RECORD PLANS

PROPOSED ROUNDABOUT IMPROVEMENTS TOWN OF HYDE PARK COUNTY OF LAMOILLE VT 15 & VT 100 - MINOR ARTERIALS

DIRECTOR OF PROJECT DELIVERY	
APPROVED:	<i>Patti Coburn</i> DATE 11/12/2015
PROJECT MANAGER :	PATTI COBURN, P.E.
PROJECT NAME :	HYDE PARK
PROJECT NUMBER :	HES 030-2(34) RE-ADVERTISED
SHEET 1 OF 26 SHEETS

**SPLITTER ISLAND DETAIL**  
NOT TO SCALE

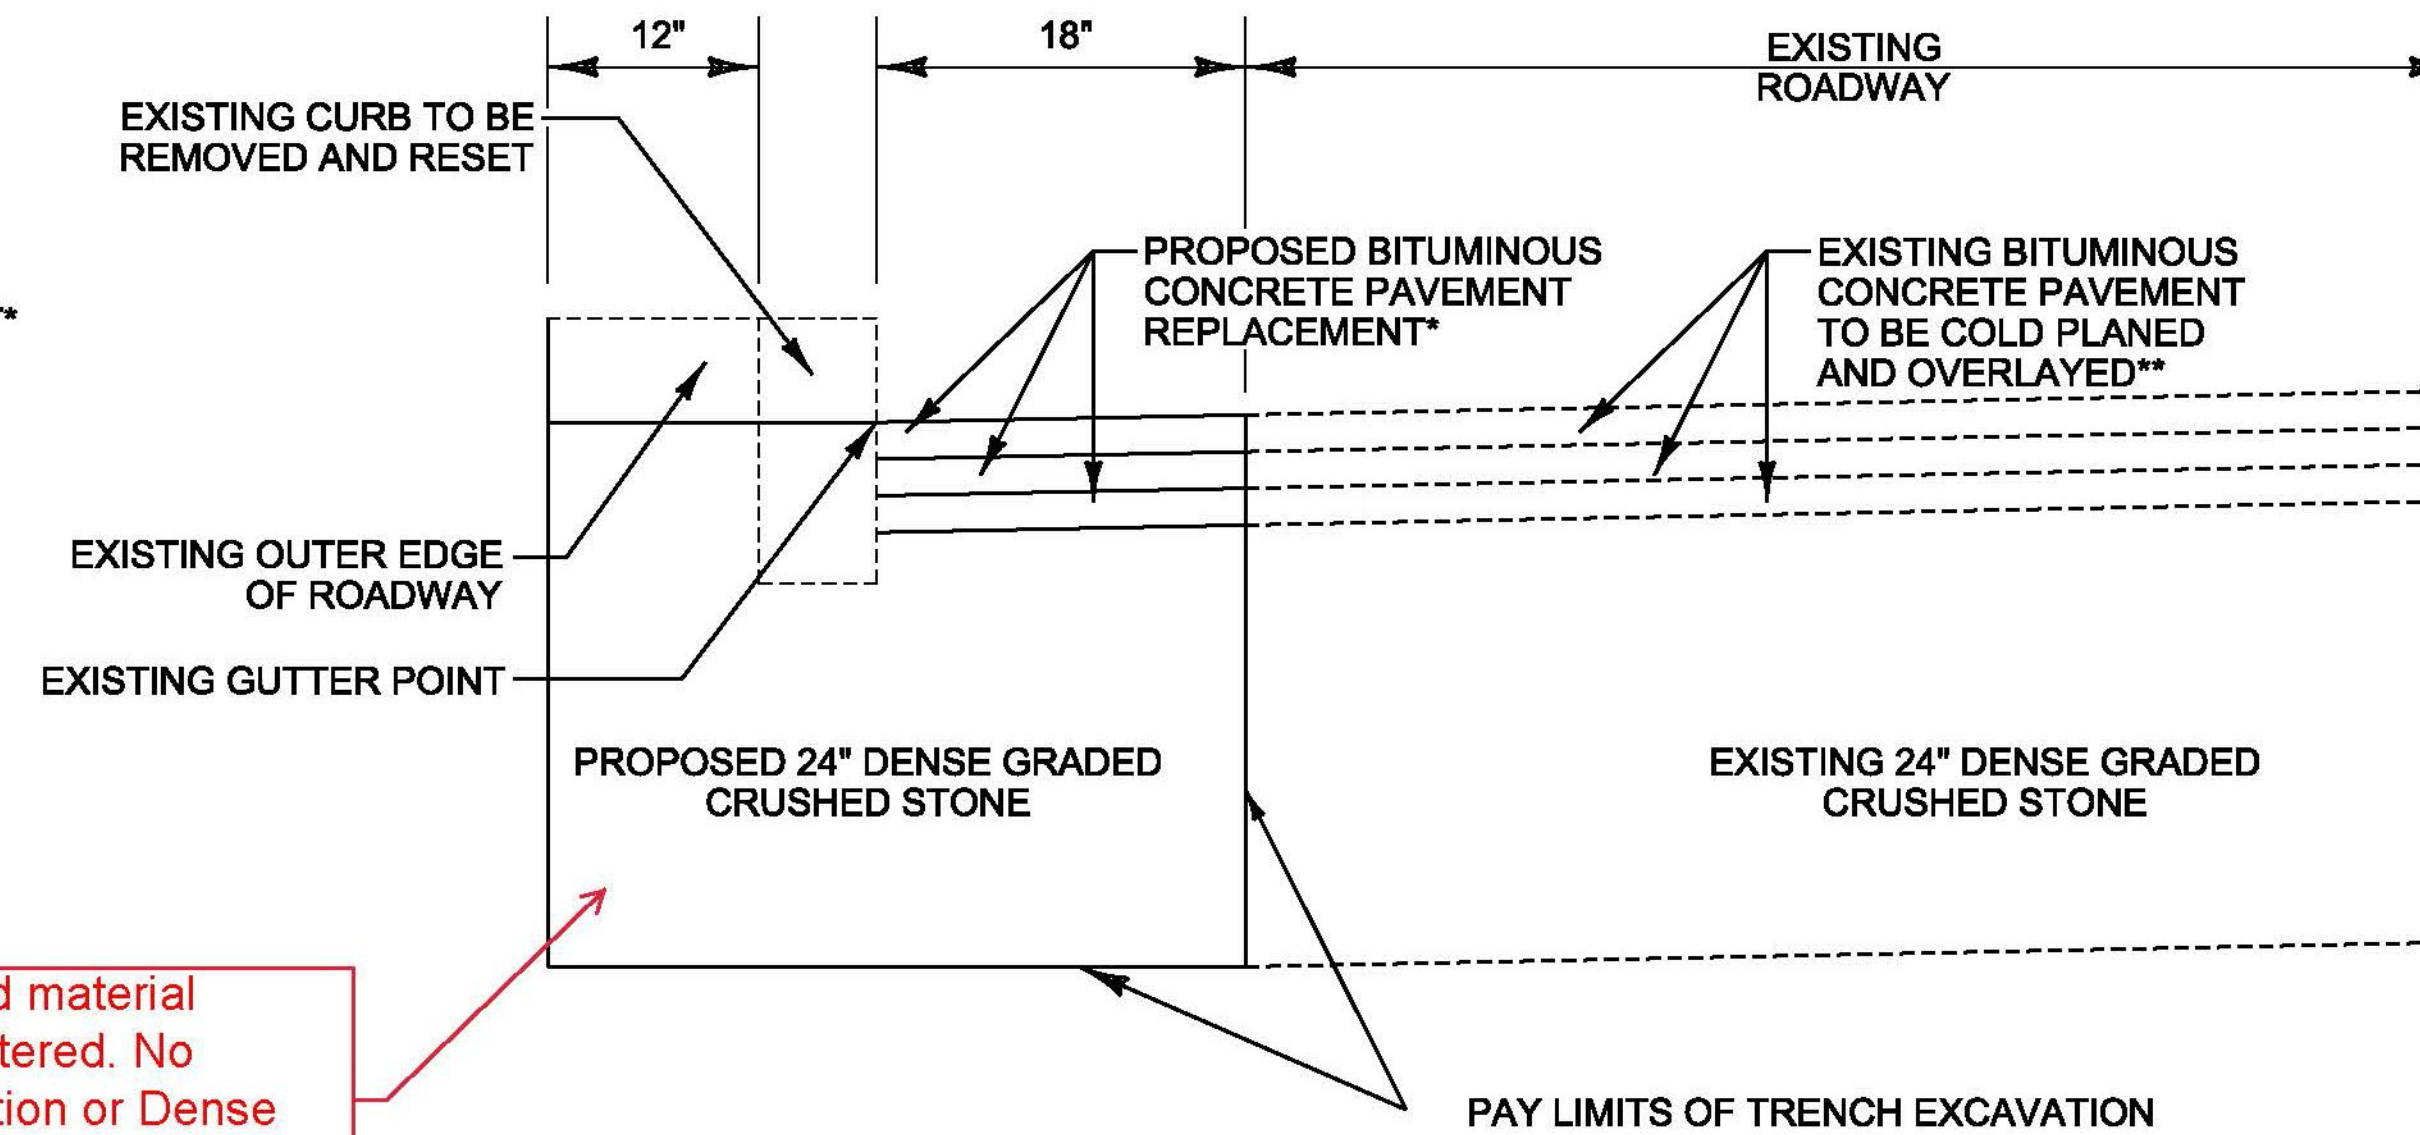
All good material encountered. No excavation or Dense Graded required.

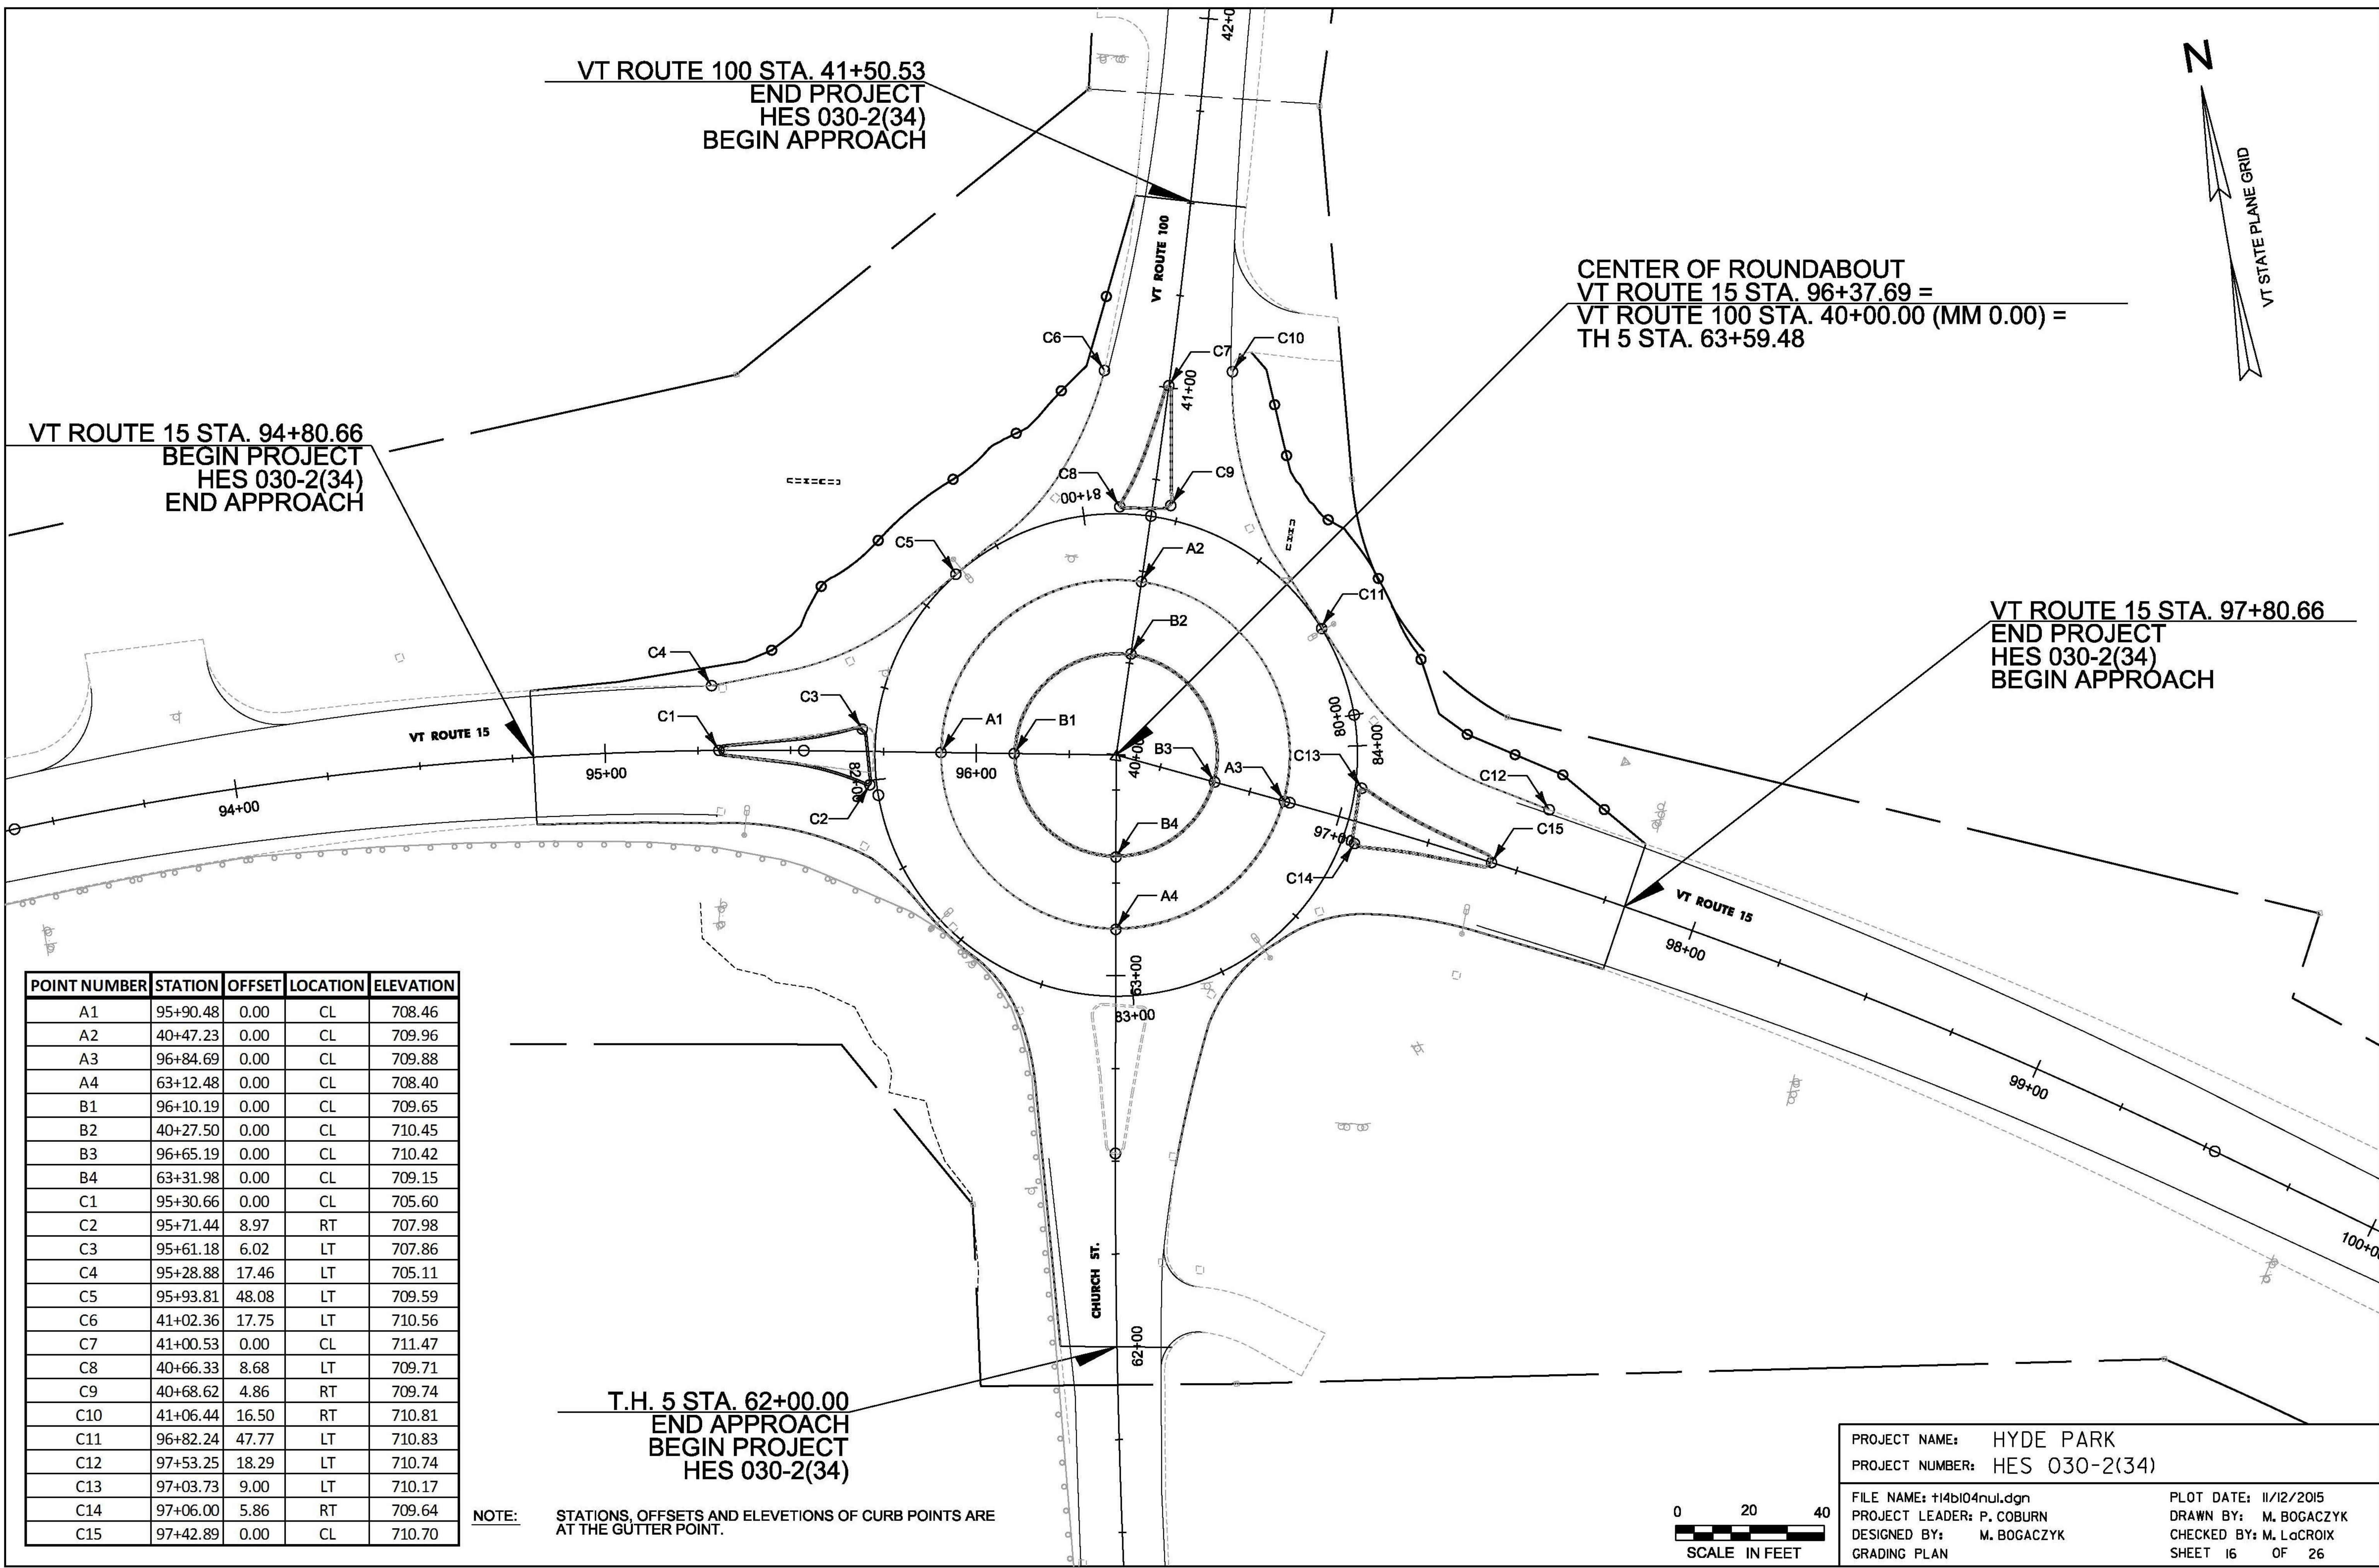
REMOVING SIGNS  
AS SHOWN - 21 EA **24 EA**  
ERECTING SALVAGED SIGNS  
AS SHOWN - 21 EA **24 EA**  
SETTING SALVAGED POSTS  
AS SHOWN - 10 EA **13 EA**

FILE NAME: t14b104land.dgn  
PROJECT LEADER: P. COBURN  
DESIGNED BY: M. BOGACZYK  
LANDSCAPING PLAN

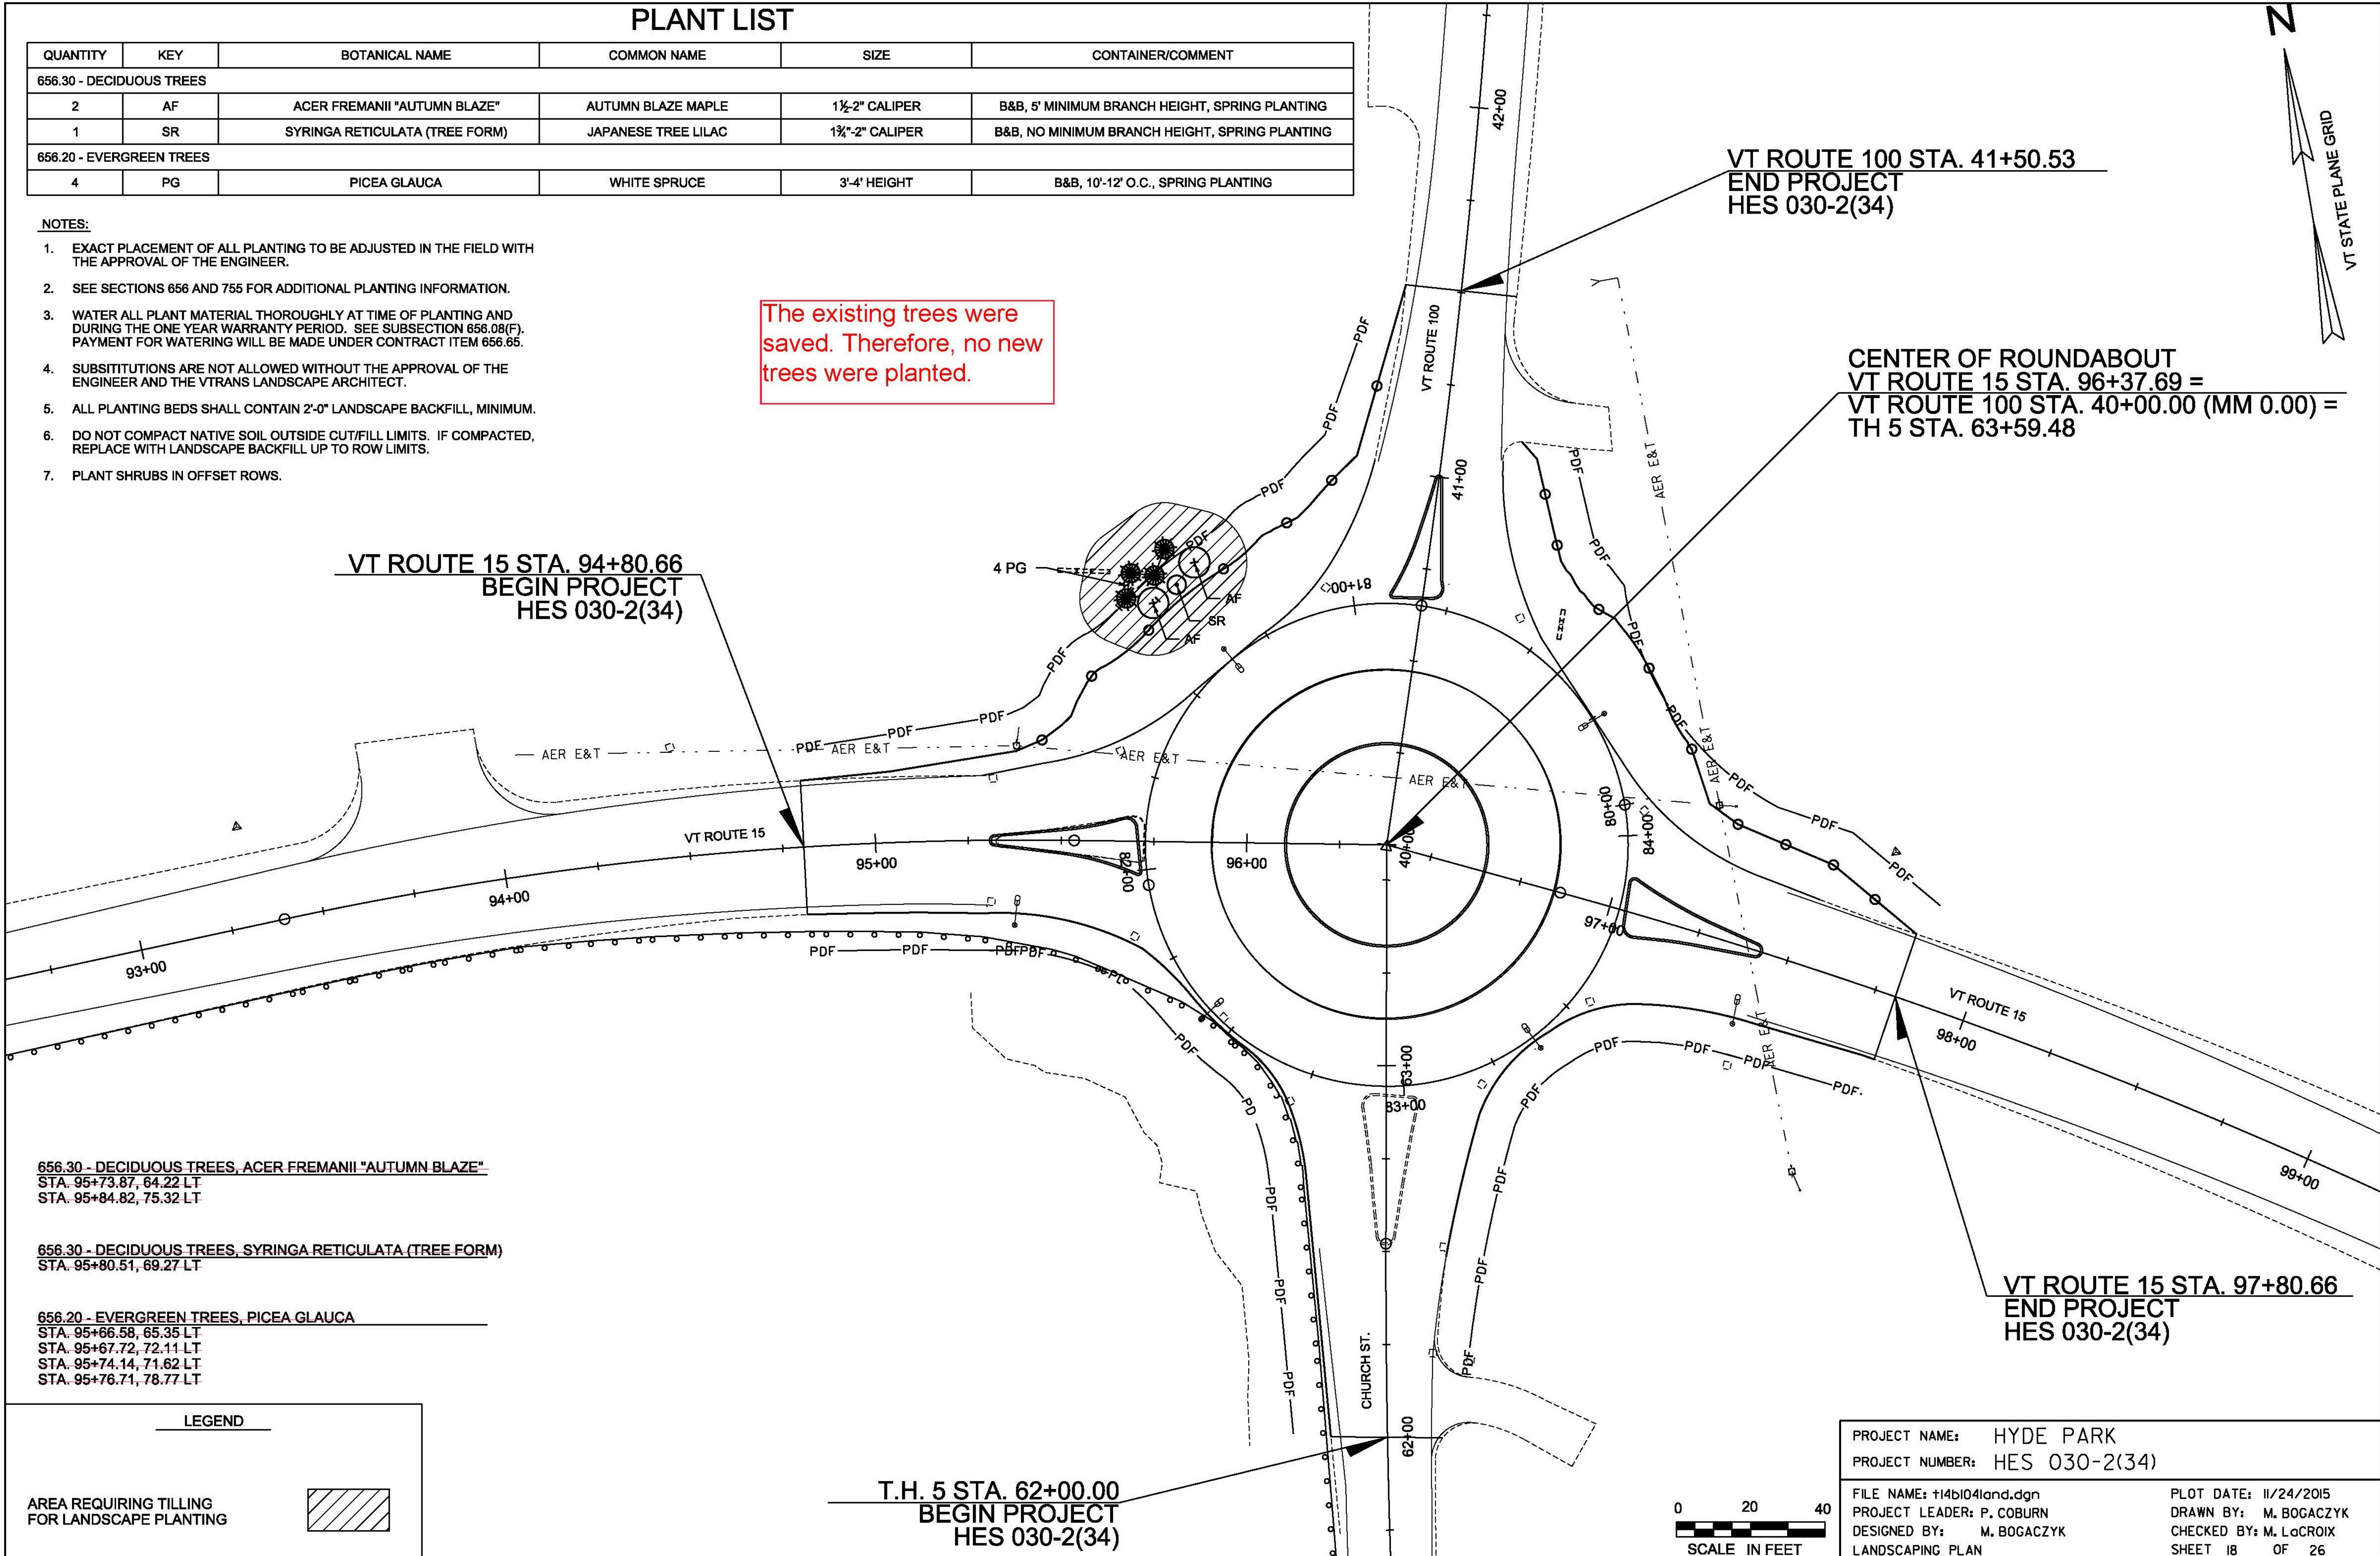
The existing trees were saved. Therefore, no new trees were planted.
